CTC Area of study – Climbable Guards

2007/2008 Code Changes

Proponent: CTC

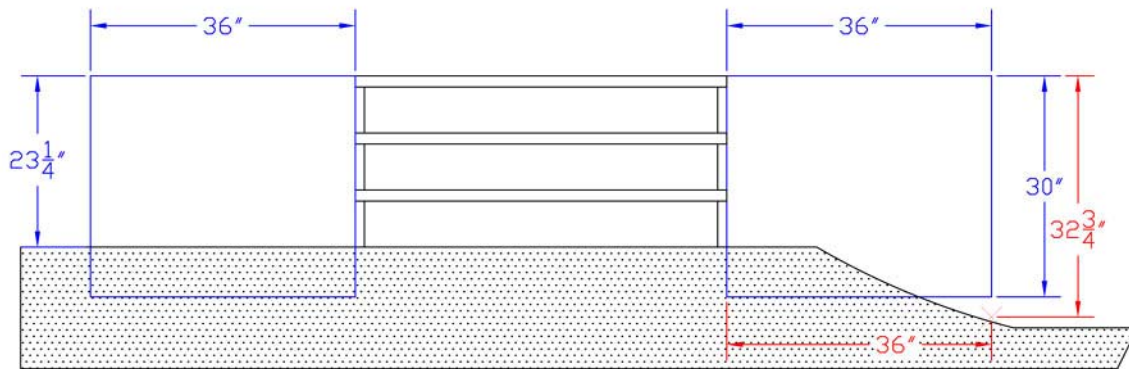
The key part of this change to IBC 1013.1 is submitted in order to clarify how the height measurement which triggers the guard requirement is made relative to proximity to the adjacent fall-off. This is illustrated in the following figure:

The view is taken from the landing of a 3 riser stair, looking towards the face of the risers.

1013.1 (SUPP) Where required. Guards shall be located along open-sided walking surfaces, including mezzanines, equipment platforms, stairways, stairs, ramps and landings, that are located more than 30 inches measured vertically to the floor or grade below at any point within 36 inches (914 mm) horizontally to the edge of the open side above the floor or grade below. Guards shall be adequate in strength and attachment in accordance with Section 1607.7. ~~Where glass is used to provide a guard or as a portion of the guard system, the guard shall also comply with Section 2407. Guards shall also be located along glazed sides of stairways, ramps and landings that are located more than 30 inches (762 mm) above the floor or grade below where the glazing provided does not meet the strength and attachment requirements in Section 1607.7.~~
